Access Compliance Report

Public Rights-of-Way

(Curb Ramps)

Intersection ID: 45222	Main Street: LISSADELL_CR	Cross Street: HARCOMBE_DR	Location: NE
ADA ID: 368749AB4ADC	Ramp Type: PerpDiag	Initial Pass/Fail: Fail	Overall Compliance: No
Severity Score: 21.25			
Codes/Mitigation Info/Possible Solution		Field Measurements/Component Compliance

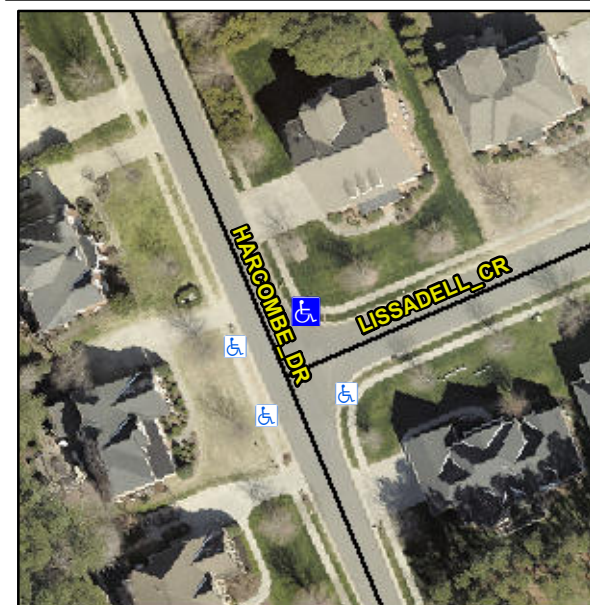
Not Found, R304.5.1, R304.2.2

Compliance	Description	Data	Compliance	Description	Data
N/A	Ramp Length (in)	47.0	No	Ramp Slope (%)	11.0
No	Ramp Width (in)	46.5	Yes	Ramp XSlope (%)	0.0
N/A	Flare Type LT	N/A	N/A	Flare Type RT	N/A
N/A	Flare Slope LT (%)	N/A	N/A	Flare Slope RT (%)	N/A
N/A	Flare Traversable LT?	N/A	N/A	Flare Traversable RT?	N/A
N/A	Landing Length (in)	N/A	N/A	DWS Provided?	N/A
N/A	Landing Width (in)	N/A	N/A	DWS Contrast?	N/A
N/A	Landing Slope (%)	N/A	N/A	DWS Length (in)	N/A
N/A	Landing X Slope (%)	N/A	N/A	DWS Full Width?	N/A
N/A	Landing Curb? (Y/N)	N/A	N/A	DWS Offset (in)	N/A
N/A	Shared Landing?	N/A			
N/A	Gutter Ponding?	N/A	N/A	Gutter Slope (%)	N/A
N/A	Gutter Lip Ht (in)	N/A	N/A	Gutter X Slope (%)	N/A
N/A	Painted X Walk1?	No	N/A	Painted X Walk2?	No
	X Walk 1 Direction	To W		X Walk 2 Direction	To S
N/A	X Walk 1 Width (in)	N/A	N/A	X Walk 2 Width (in)	N/A
	X Walk 1 Slope (%)	1.4		X Walk 2 Slope (%)	3.4
	X Walk 1 X Slope (%)	3.3		X Walk 2 X Slope (%)	0.0

Remove & Replace Curb Ramp With Two New Directional Ramps or Equivalent.
